TECHNICAL BULLETIN
Bell Helicopter **TEXTRON**

No. 212-02-188

MODEL AFFECTED: 212

SUBJECT: TRANSMISSION OIL COOLER LINES P/N 412-040-243-101 & 412-040-244-101, INTRODUCTION OF

Figure 1. Transmission Oil Cooler Lines

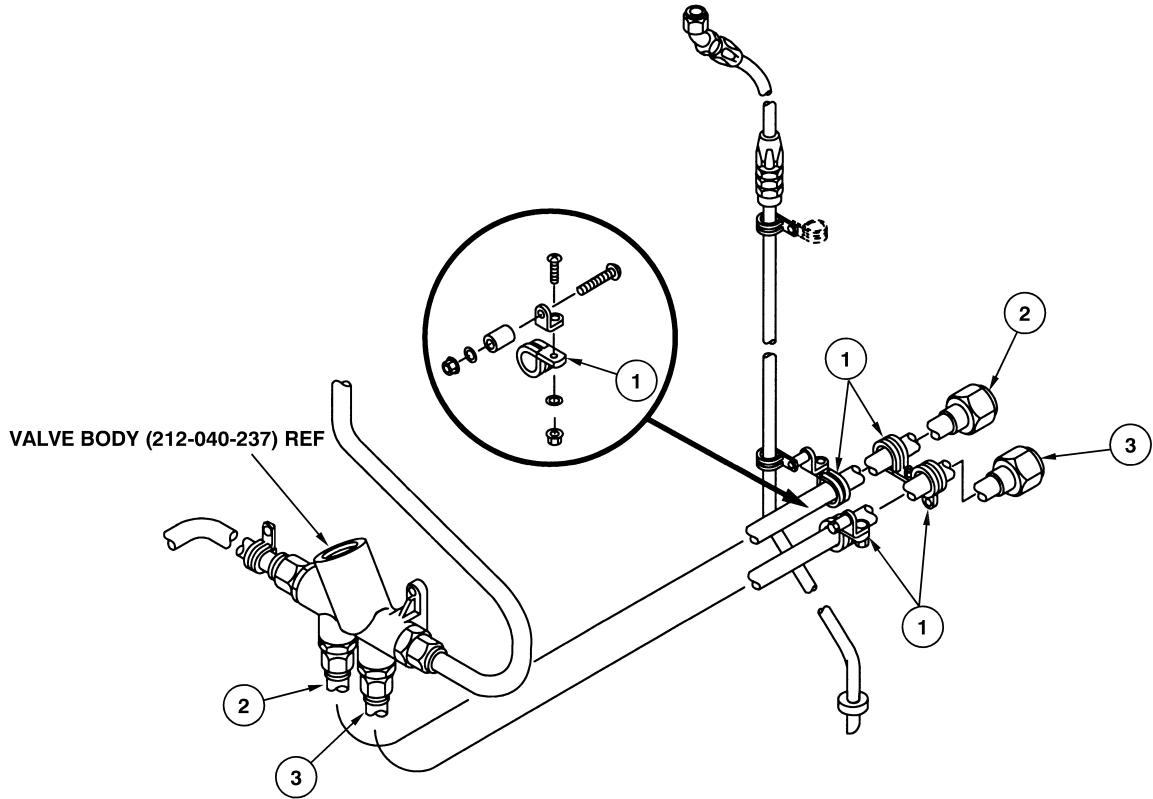
Bell Helicopters is introducing CRES oil cooler lines to reduce corrosion and fatigue related damage. Concurrently, the retention clamps are to be replaced.

1. Drain oil from cooling system.
2. Remove clamps P/N MS21919WDG (Figure 1, Items 1). Retain attaching hardware for reuse or replace with similar type as required.
3. Remove tubes P/N 212-040-234-001 (Item 2) and P/N 212-040-233-001 (Item 3).

4. Install the replacement CRES oil tubes P/N 412-040-244-101 (Item 2) and P/N 412-040-243-101 (Item 3) leaving the attaching tube nuts loose at this time.

5. Tighten tube nuts on the replacement tubes (Items 2 & 3). If you suspect a load has occurred, loosen the tube nuts and reapply the torque, ensuring a twisting or bending load has not been induced in the tubes.

6. Install the replacements clamps P/N MS21919WCG10 (Items 1) as indicated in Figure 1. Oil lines (Items 2 & 3) retained by the clamps (Items 1) must be installed without applying a bending load.
7. Replenish previously drained oil, accomplish ground run and leak check procedures.
8. Make entry in helicopter historical records indicating compliance with this Technical Bulletin.
